TOPIC Snug Harbor – Multiple Family Site Plan Review

Subject: VLO-24-01 Snug Harbor (160 Heights Road), Site Plan Review #1

Re: Snug Harbor
Site Plan Review #1
NFE Job No. 0039

MOCERI CUSTOM HOMES
SNUG HARBOR
4-UNIT BUILDING

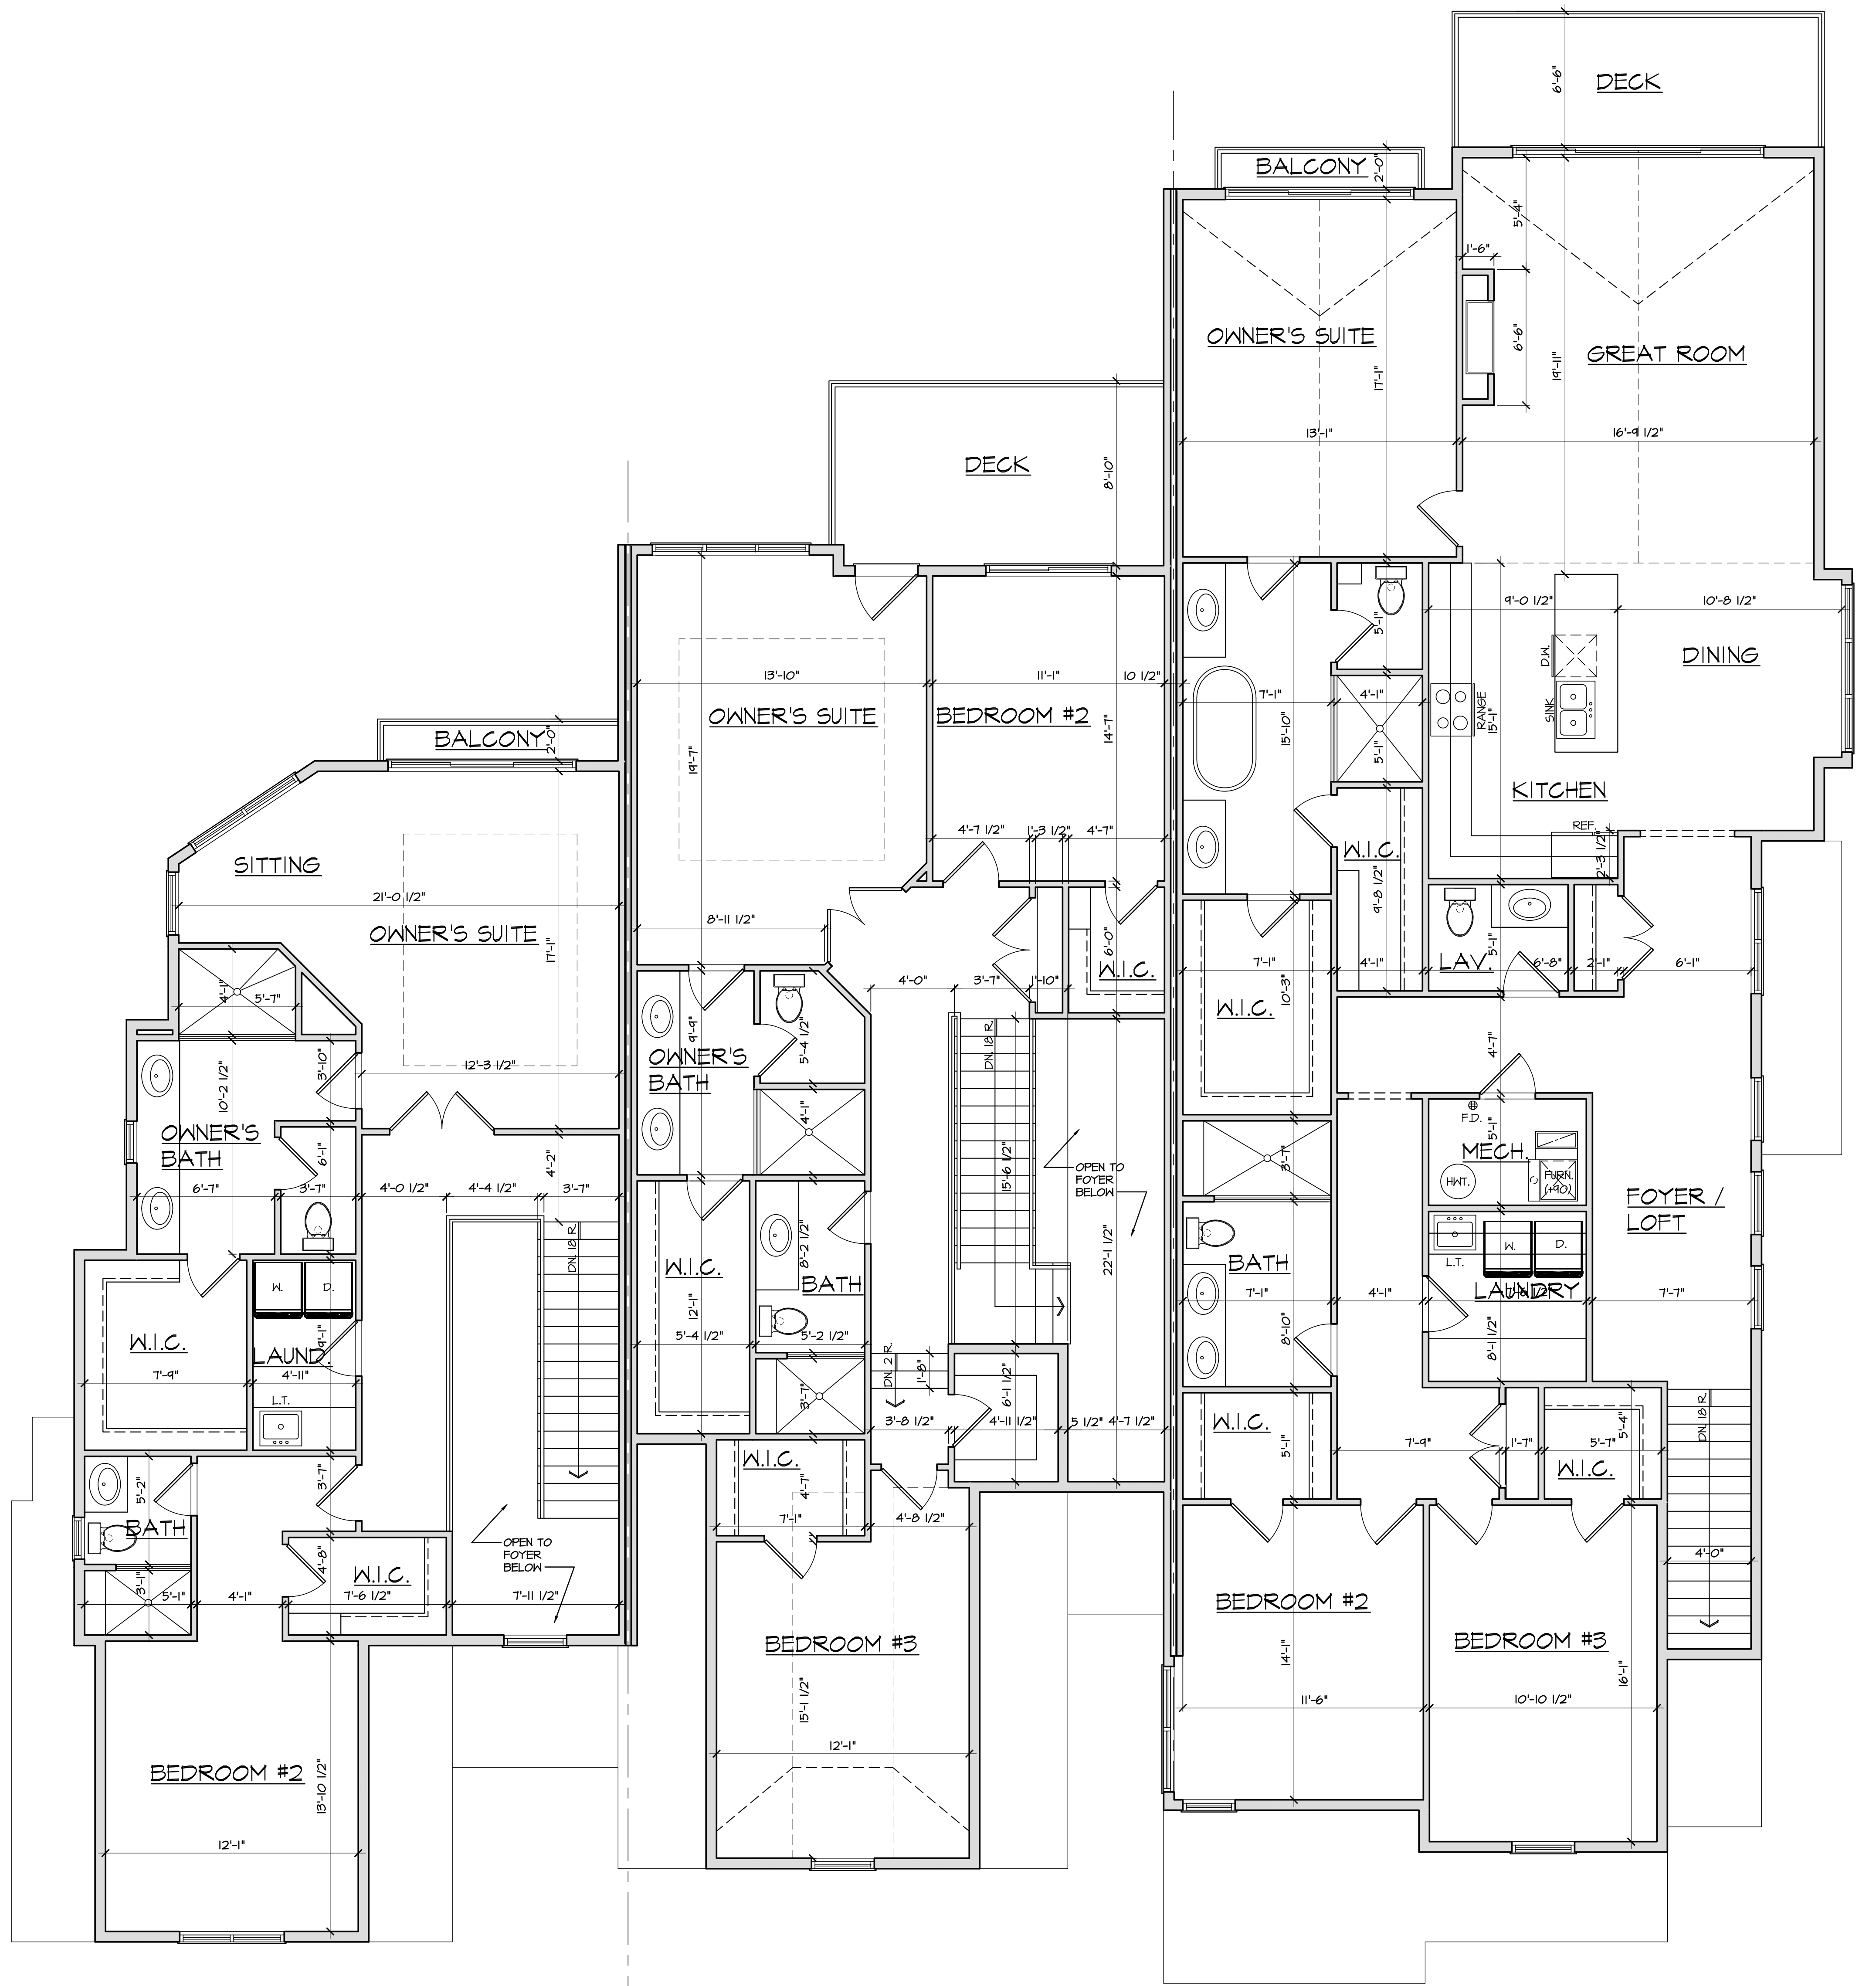
Building Materials. The proposed elevations feature material types; however, the material colors are not specified within the plans. The proposed materials include board and batten siding, horizontal siding, wood accents, and asphalt and metal roofing.

The applicant must specify material colors. This can be depicted with renderings and building elevations. Material samples and color elevations must be provided to and approved by the Planning Commission.
